Marvel-Schebler Aircraft Carburetors LLC

Service Bulletin: SB-20
Original Date: August 31st, 2011

SUBJECT: USE OF INCOMPATIBLE CLIP AND FLOAT CAN AFFECT FLOAT OPERATION

PHOTO 1
DAMAGE TO FLOAT FRAME CAUSED
BY FLAT CLIP.

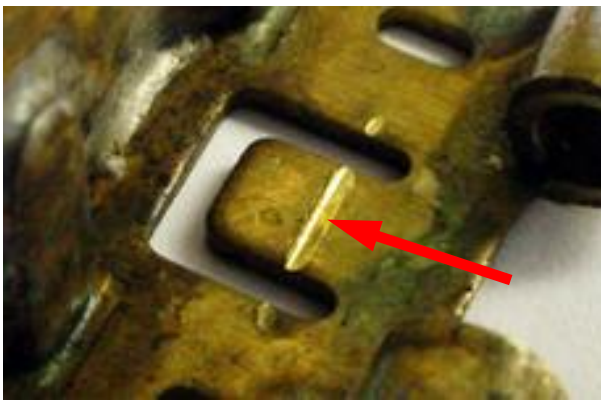
- b. To remove from MSA HA-6™ carburetors AVStar floats part number AV30-768 and AVStar clips part number AV29-182 or MSA clips part number 29-182.

4. **Background:** The clips affected by this bulletin can wear into AVStar float frames and cause a notch to form; *See* Photo 1. **WARNING:** NEVER use a AV30-768 float with a flat clip AV29-182 or MSA 29-182 in MSA HA-6™ carburetors; *See* Photo 2. MSA has never approved the use of the combination of a 30-768 type float and a 29-182 type clip in its carburetors. Use MSA clip 29-182 ONLY with float part number 30-860 in HA-6™ carburetors; *See* Photo 3.

6. **Compliance:**
 - a. Remove AV30-768 floats and AV-182 clips (or MSA 29-182 clips where installed in conjunction with an AV30-768 float) from MSA HA-6™ carburetors.
 - b. Install MSA float 30-860 and clip 29-182. Obliterate the letters “MF” (if they appear) on the data tag with a round nose punch. Stamp the letters “CC” on the data tag to indicate compliance with this service bulletin.
 - c. Perform all carburetor work in accordance with MSA Carburetor Service Manual MSACSM Rev-0, Chg-0 date 08/19/11 for HA-6™ series carburetors and MSA Service Bulletins, www.msacarbs.com. See MSA service bulletin number SB-2 for additional float information.
